Design Rules Summary

for Drawing Layers

質問・確認事項

2026/01/06

DIODE

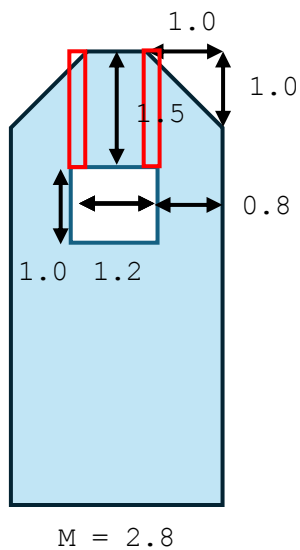
リファレンス・マニュアルTable I-1-1によればダイオードはP/NどちらもPM+NMインプラと記載

DP : PM+NM

DN : PM+NM

リファレンス・マニュアル図6.1/6.2にも同様の指示があるが、

リファレンス・マニュアル図6.12/6.13に(ESD)では

DP : NM

DN : PM

と指示がある。本当はどちらでしょう？違う場合は、Spiceモデルを公開頂けると幸いです。

また、ESD用NMOSのSPICEモデルも公開頂けると幸いです。
